**PLEASANT PRAIRIE PLAN COMMISSION MEETING  
VILLAGE HALL AUDITORIUM  
9915 39<sup>th</sup> AVENUE  
PLEASANT PRAIRIE, WISCONSIN  
6:00 P.M.  
DECEMBER 9, 2019  
AGENDA**

## VILLAGE STAFF REPORT OF DECEMBER 9, 2019

Consider the request of Jeff Smith, agent for Verde 88<sup>th</sup> Avenue, LLC owners of the property located at 11589 88<sup>th</sup> Avenue in the LakeView Corporate Park for approval of **Final Site and Operational Plans** for an 86,808 square foot warehouse distribution addition for Volkswagen Group of America, LLC.

Consider the required of Mark Eberle, P.E. with Nielsen, Madsen, and Barber S.C. for **Site and Operational Plans** approval for a parking lot expansion for Good Foods Group, LLC located south of their facility at 10100 88<sup>th</sup> Avenue in LakeView Corporate Park.

11 "NO SEMI"  
PARKING" SIGN  
DETAIL

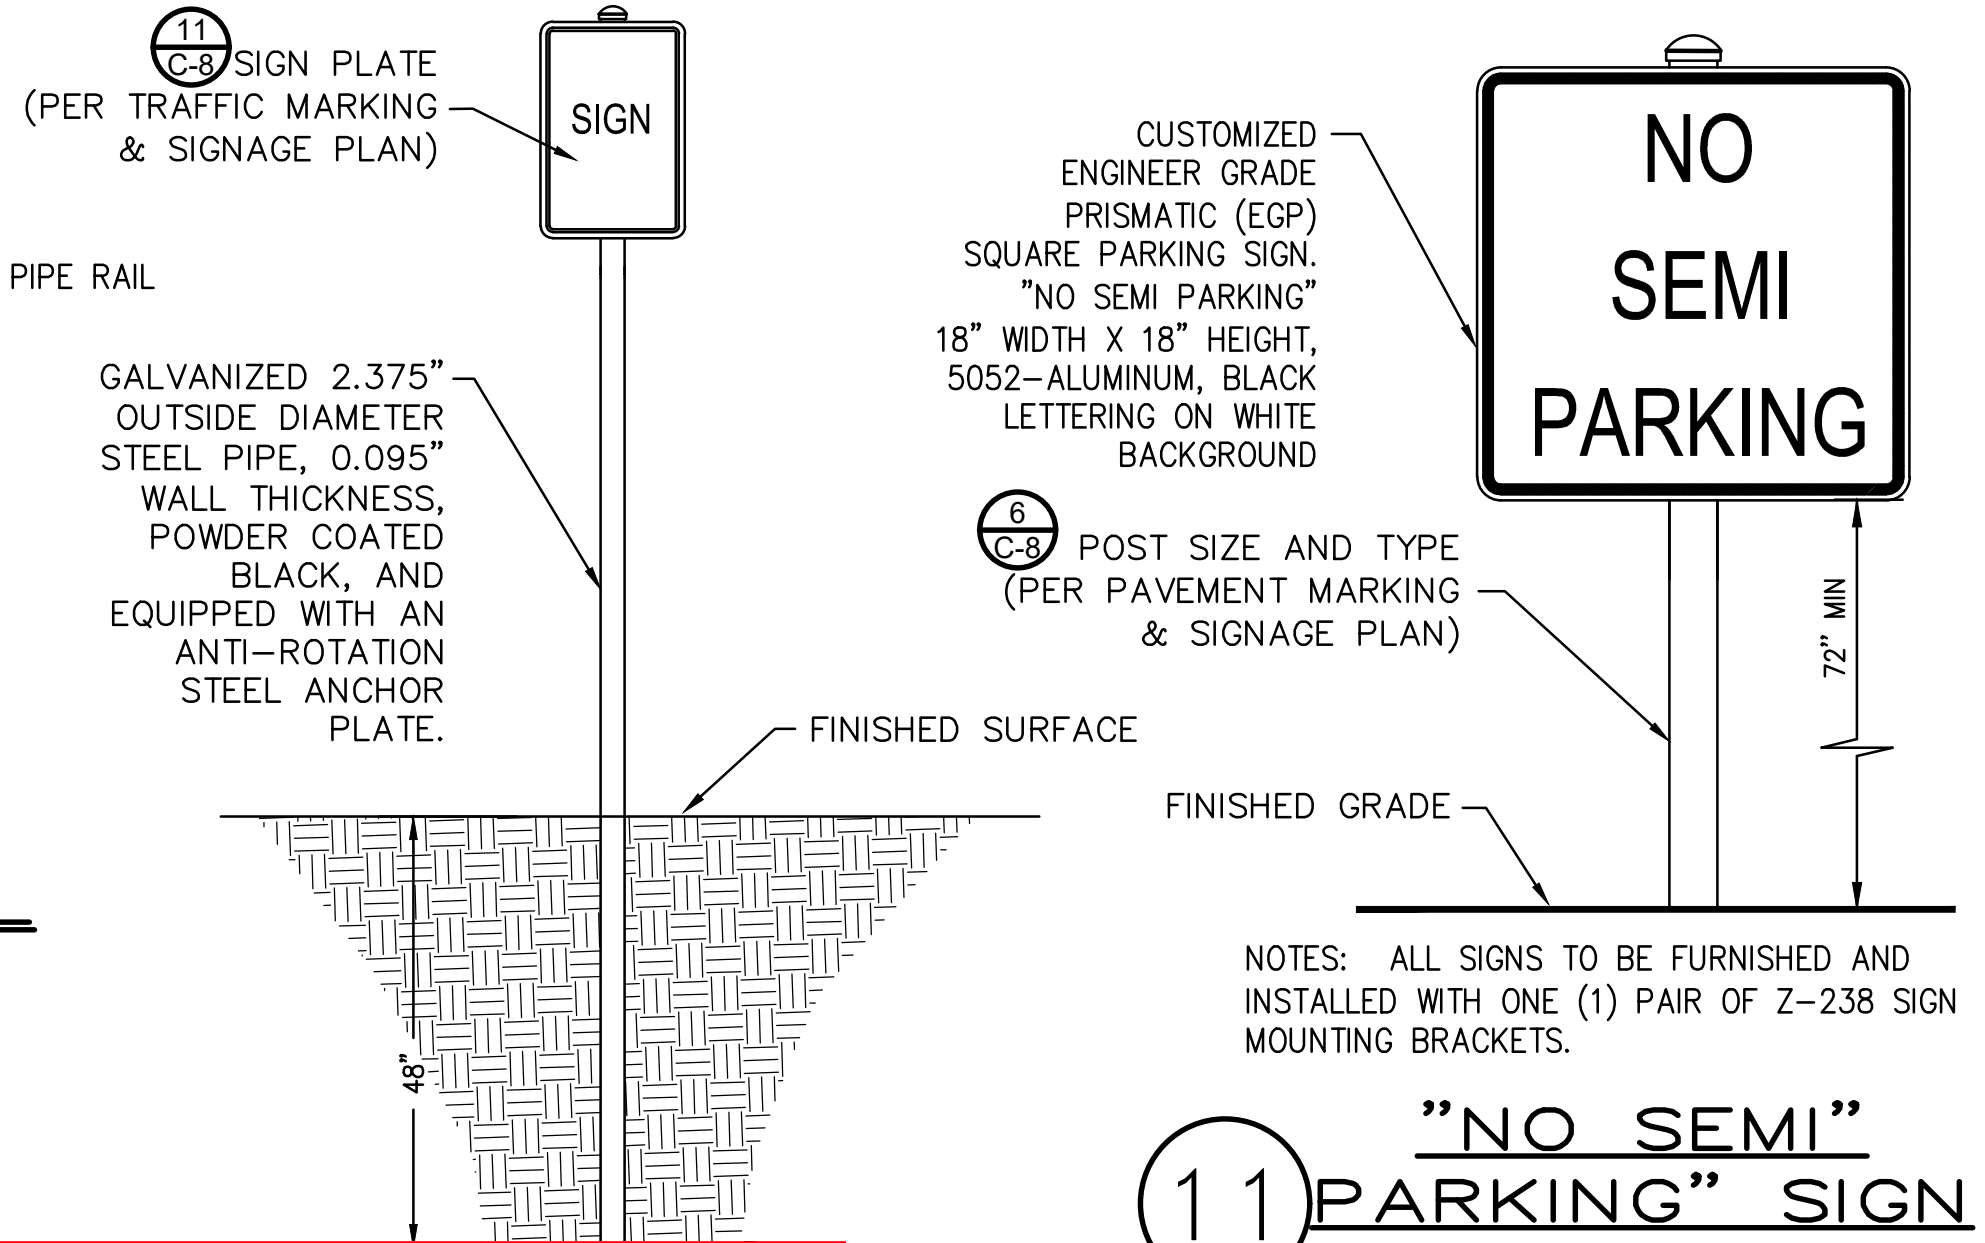
- a. See **attached** comments dated November 12, 2019 from the Village Engineering Department.
  - b. Remove the no semi truck parking signs on 102<sup>nd</sup> Street and the sign detail. No parking on the public street is required to be approved by ordinance and when approved, appropriate signs will be installed by the Village.
